TO:	COUNCIL ASSESSMENT PANEL
DATE:	24 FEBRUARY 2021
SUBJECT:	COUNCIL ASSESSMENT REPORT
AUTHOR:	DEAN SPASIC
	DEVELOPMENT OFFICER PLANNING
ATTACHMENTS:	1. LOCALITY PLAN
	2. PROPOSED PLANS
	3. STATEMENT OF REPRESENTATION
	4. APPLICANT'S REPLY TO STATEMENT OF REPRESENTATION

DA NO.		110/00940/20
	•	
APPLICANT	:	DESIGNTECH STUDIO
LOCATION	:	17 OLD TAPLEYS HILL ROAD GLENELG NORTH
DEVELOPMENT PLAN	•	CONSOLIDATED 2 JUNE 2016
ZONE AND POLICY AREA	:	RESIDENTIAL CHARACTER ZONE STREETSCAPE CHARACTER (GLENELG
		& GLENELG NORTH) POLICY AREA 14
NATURE OF DEVELOPMENT	:	MERIT
PROPOSAL	:	ALTERATIONS AND TWO STOREY ADDITION WITH BALCONY TO REAR
		OF EXISTING SINGLE STOREY SEMI-DETACHED DWELLING, GROUND
		LEVEL DECK AND CARPORT
EXISTING USE	:	RESIDENTIAL
CATEGORY	:	TWO
REPRESENTATIONS	:	ONE
RECOMMENDATION	:	DEVELOPMENT PLAN CONSENT WITH CONDITIONS

The proposal comprises the internal alterations to a single storey semi-detached dwelling, upper storey addition with balcony to rear, and ground level deck and carport.

# EXISTING SHADOW DIAGRAM - JUNE 21 9AM

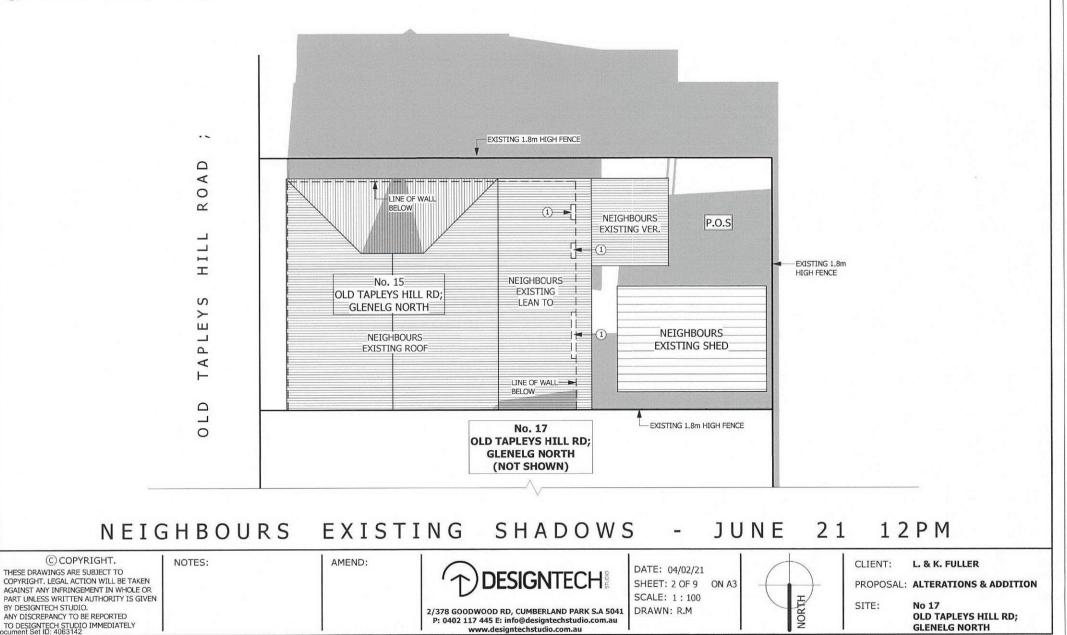
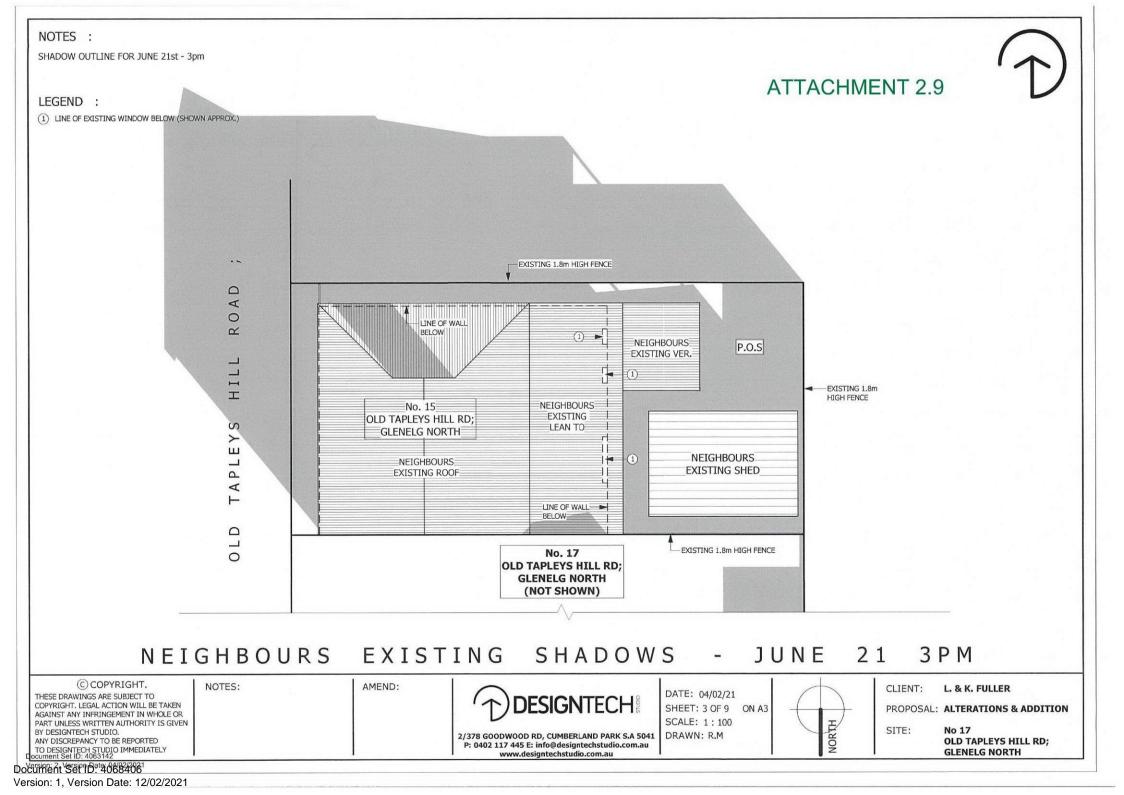
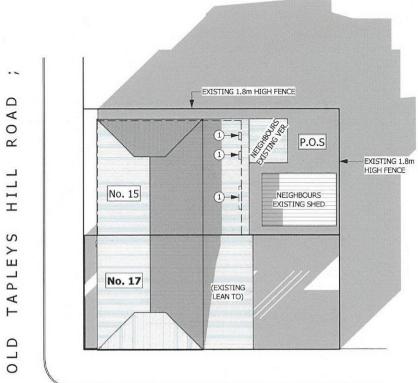
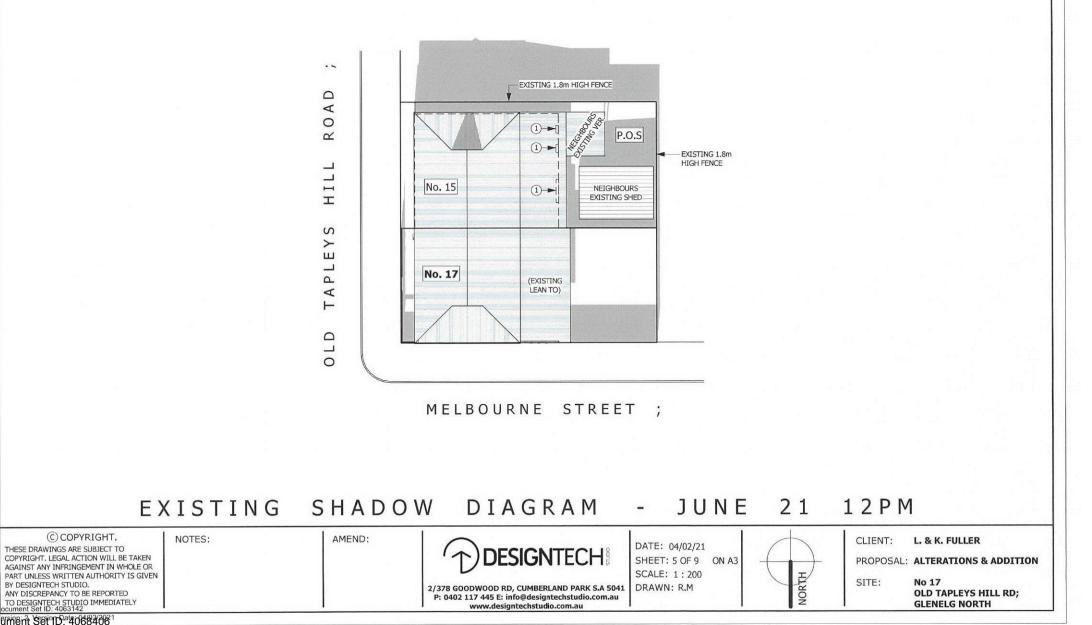
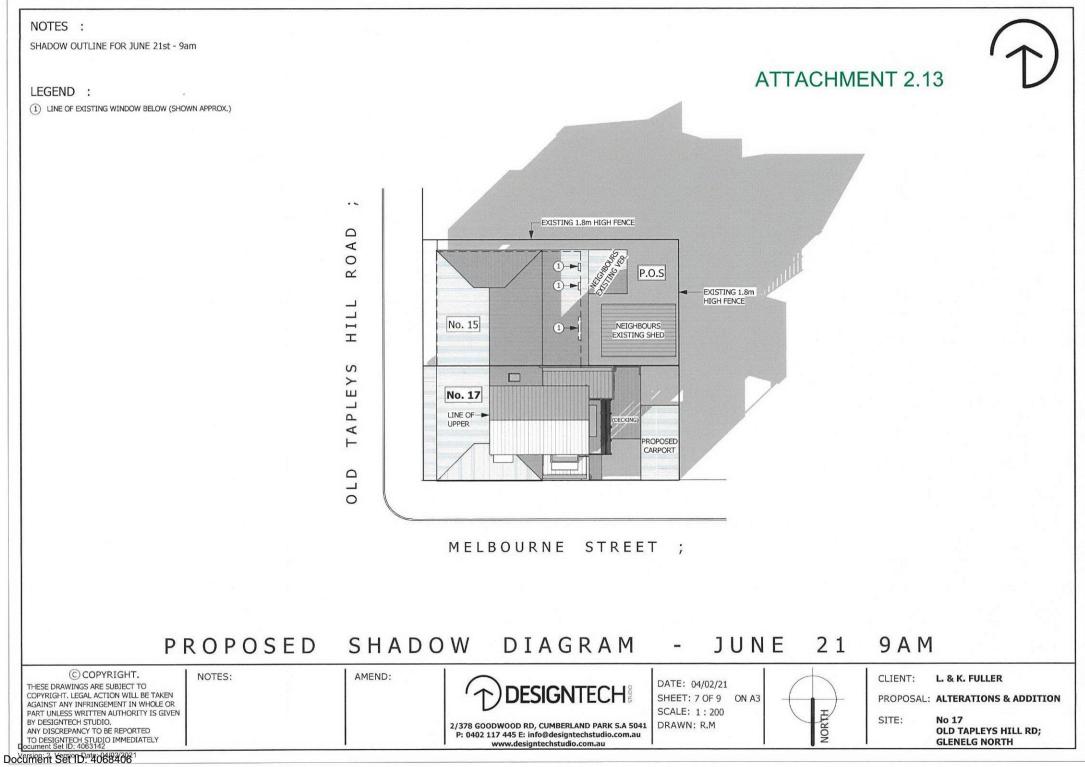
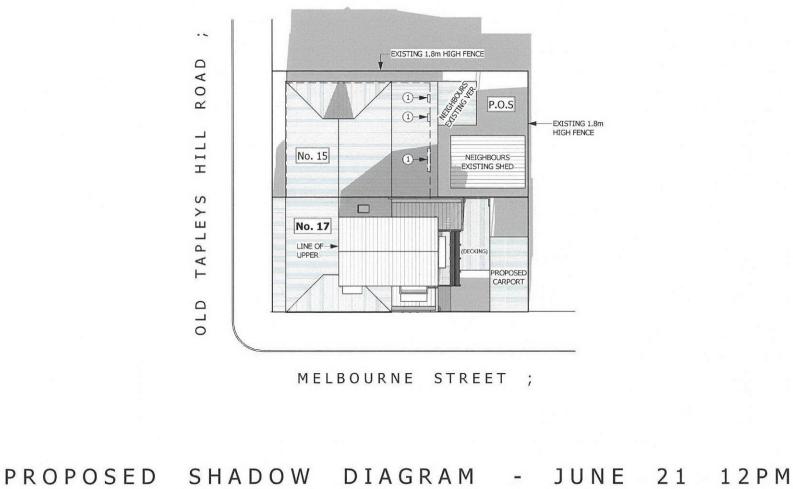
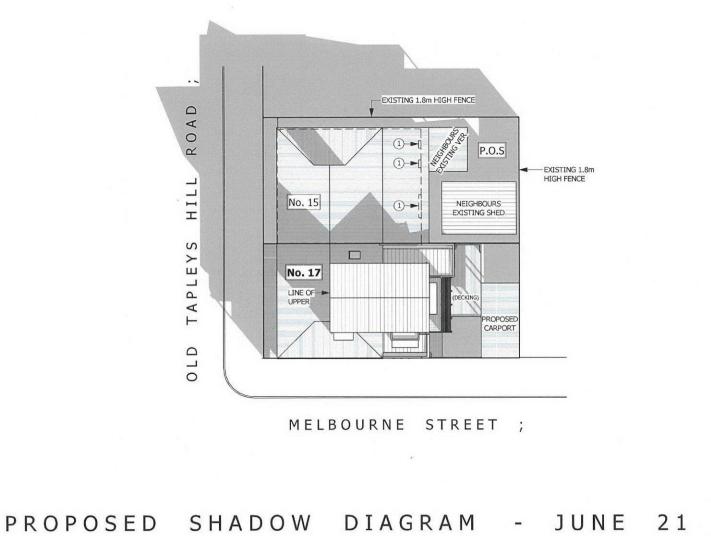
5. Due to new wall on boundary to south over shadowing to neighbour, light will be significantly reduced given neighbour's aspect of rear yard. Have shadow diagrams been provided?

2: Upper storey side setbacks are 2.0m & 1.57m respectively. As demonstrated in our 'Shadow Diagrams' provided the effects of the upper storey are negligible. In fact Ms Kiely's own shed & verandah already over shadow much of her own rear yard & property.

5: Shadow diagrams have been provided. The additional 2.5m on Southern boundary has little to no effect on overshadowing.
